REMARKS

5 This amendment is responsive to the Office Action dated
March 11, 2004.

25 With regard to the examiner's suggestion of
substituting the word --material (i.e. iron)-- in reference
Amendment for: Electron Gun for Multi-Beam Klystron by Ives et al. s/n 09/629,364

Figure 4-1

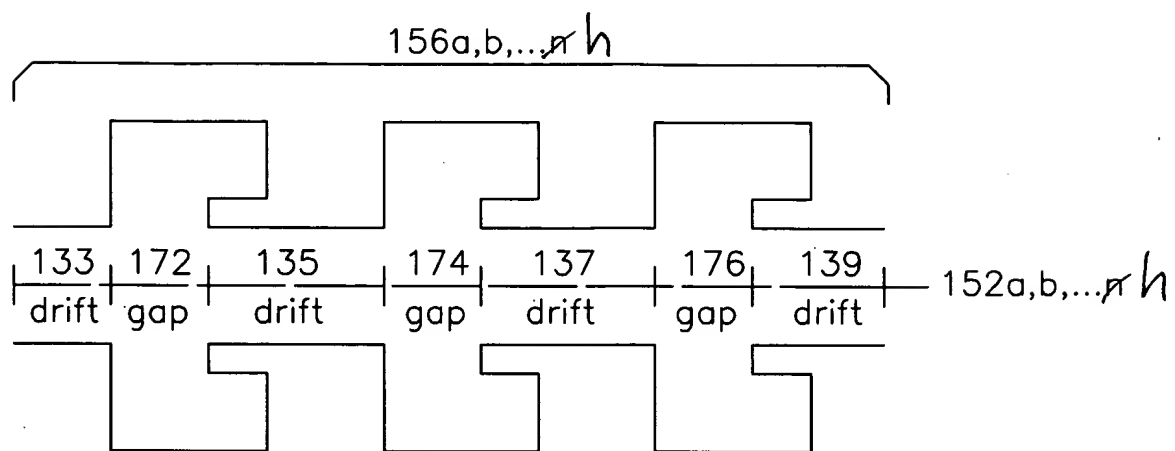
10 With regard to the use of reference labels "a..n",
applicant notes that the paragraph of page 20 line 23 has
been amended to indicate that the drawing figures illustrate
the case where $n=8$, and the subscripts have been modified to
make reference to "a..h", which are now in agreement with
15 the amended Figure 4-1, which now has subscripts in the
range "a..h". The specification makes clear that the device
may have any plurality n of electron guns, beam tunnels, and
associated structures.

With regard to the absence of subscripts on repeated
20 structures 102 and 106, applicant notes that the
specification has been amended to make reference to the
structures by subscript only. Applicant also notes that
figure 4 is a section view through structures having
suffixes "a" and "e".

Figure 4a

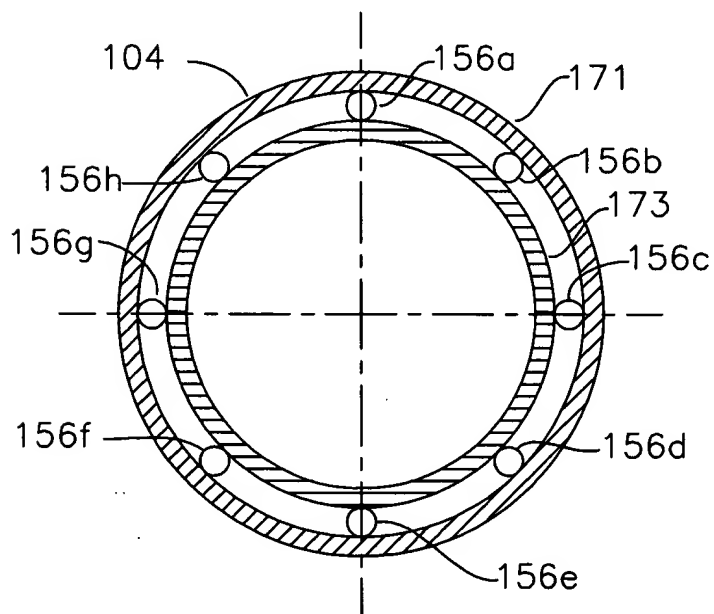
the location of the magnetic field corrector to between the electron gun assembly and the beam entrance, as shown in figure 4. This limitation in location clearly distinguishes the magnetic field corrector of the present invention from the corrector of Mourier, where the magnetic field correctors are either pairs of correctors 38, 36 of figure 4, or a single medial corrector 44 of figure 5 of Mourier. Mourier equations of derivation col 3 line 55 and col 4 line 25 (note typographical omissions of integral sign operating over range A to A') teach correcting magnetic field generators which result in either a pair of correctors at both ends 36, 38 of figure 4, or a single corrector 44 at the median of figure 5. Mourier explicitly states on column 4 line 31-35:

Figure 6c

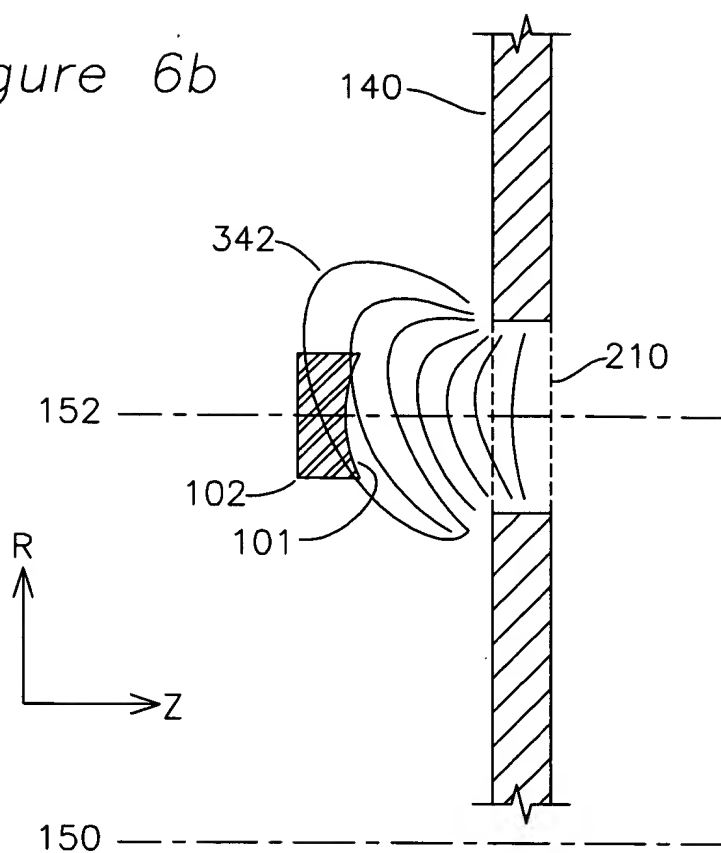
With regard to the "emitting surface 101 of cathode 102" on the replacement paragraph of page 25 line 7 &
5 8, applicant has amended drawing 6c to show emitting surface 101, and has added a sentence to the replacement paragraph reviewing the function of a prior art cathode in a traveling wave tube.
